Docket No. 71-6294
Package Identification No. USA/6294/AF
Package Model No. UNC-2901

Subject: Certificate of Compliance No. 6294 Amendment Request

CERTIFICATE OF COMPLIANCE NO. 6294, NRC DOCKET NO. 71-6294

UNC-2901 SHIPPING CONTAINER

INSERT ITEM 4.

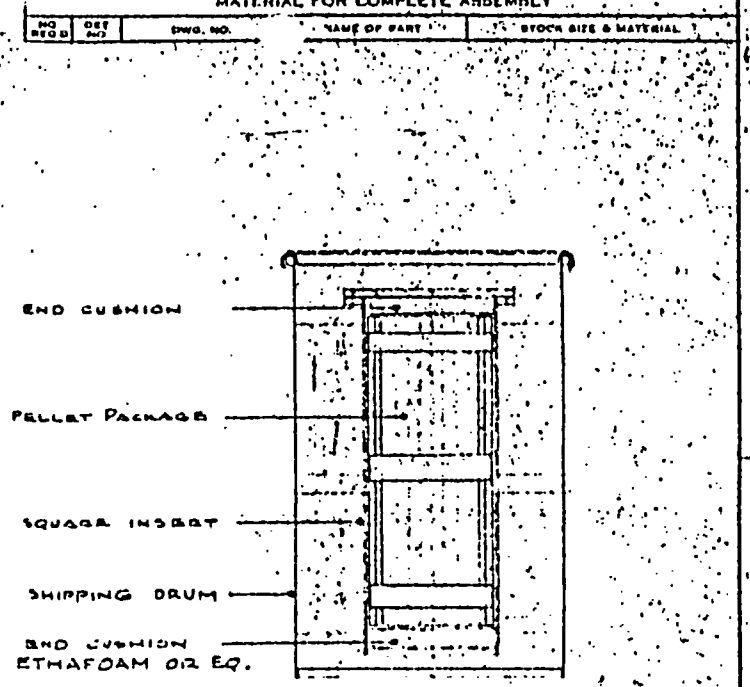
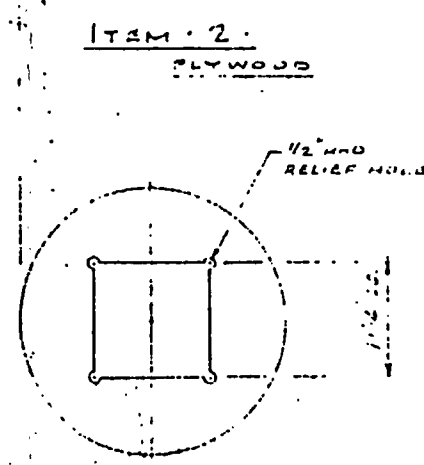
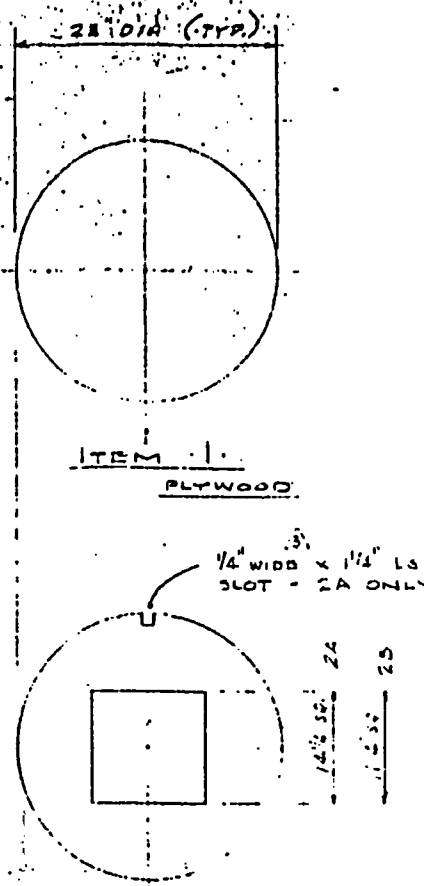
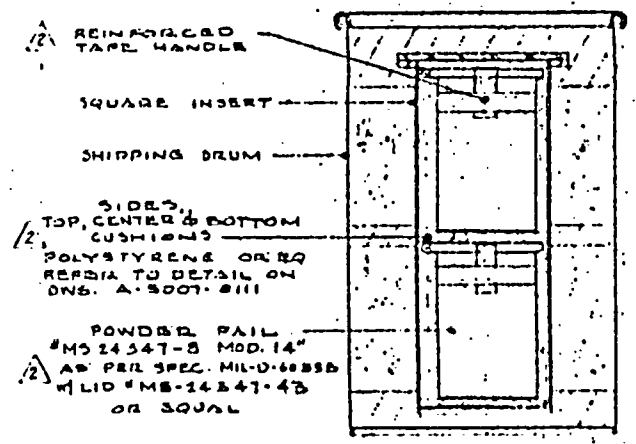
REVISIONS TO DWS. A-5007-1201									
REV	DATE	REVISION	BY	DATE	REV	DATE	REVISION	BY	DATE
5	1/3/89	INSERT ITEM 4 "AT ASSEMBLY" NOTE WAS "BY EMERSON ENG."	ER		166	8/6			
4	1/4/81	1/4" THICK ASBESTOS OR CERAMIC WAS ASBESTOS.							
3	2/7/71	CLIP 1" x 1/2" x 1/8" ADDED	TER						
2	1/25/70	CHG. FLD. HOLE SIZE, ADDED HATCH ON ELEVATION OF THE ALUM. INSERT	VAL						
1	3-17-70	RE-DRAWN	VAL
